# Chesapeake modifications to Regional Standards Third Edition

DESIGN AND CONSTRUCTION STANDARDS	
		<b>STANDARD PRECAST CONCRETE MANHOLE WITH EXTENDED MONOLITHIC BASE</b>	
		DR. BY:	DATE:
08/15/03	REV. FOR INTERNET 2003	CHK. BY:	DATE:
DATE	REVISIONS	APP. BY:	DATE:
			<b>SS_01</b>

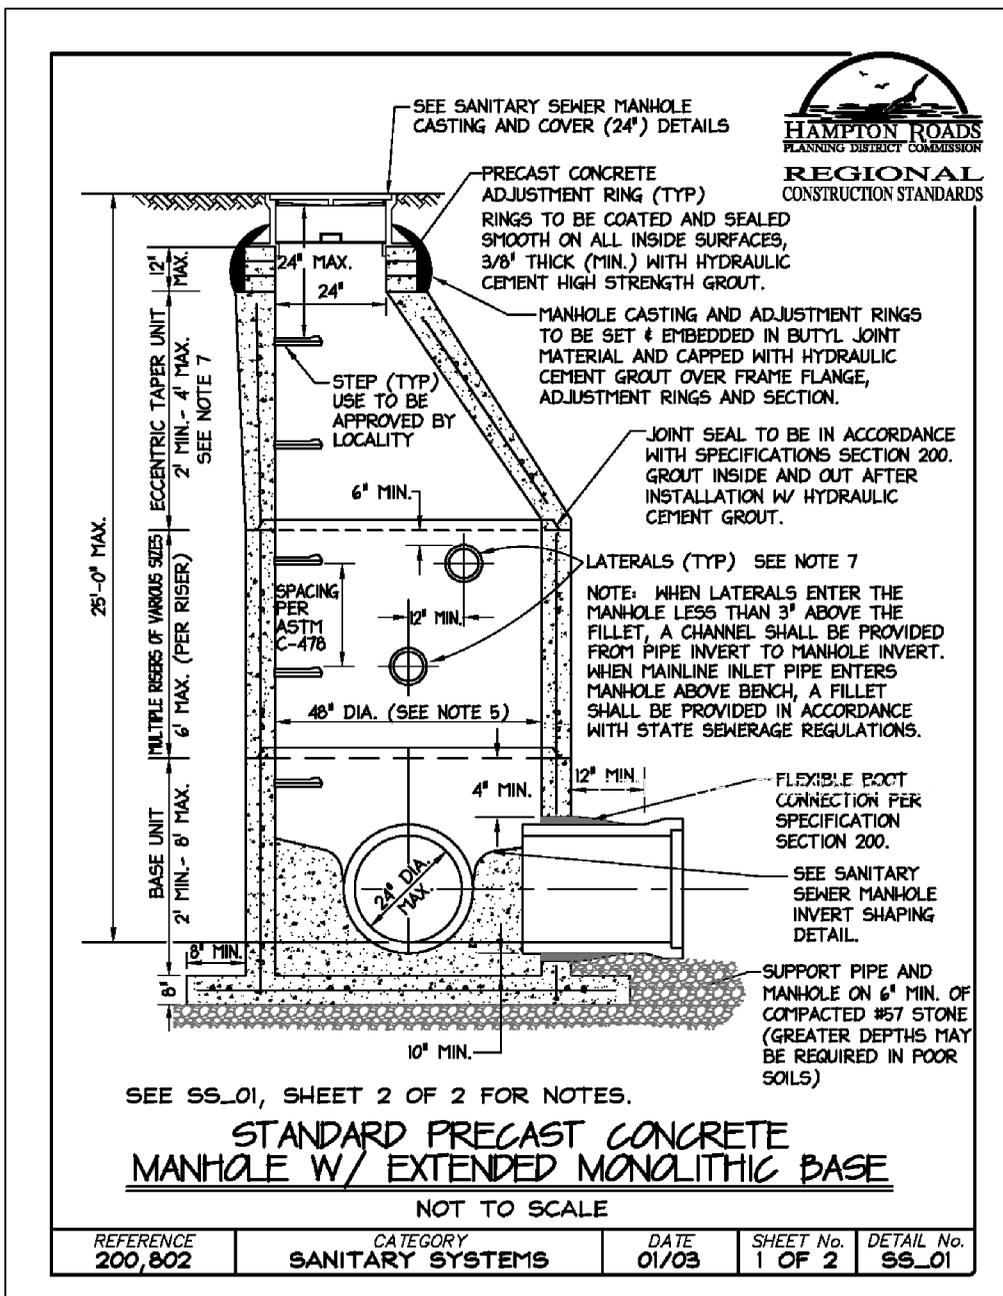
1. A minimum of one 4 inch adjustment ring to be added at time of construction to allow for future adjustments.
2. Casting to be placed over the outlet pipe.
3. Watertight insert to be provided with casting in accordance with Volumes I & III of PFM.
4. No laterals allowed in cone section without approval of the Utility Engineer.
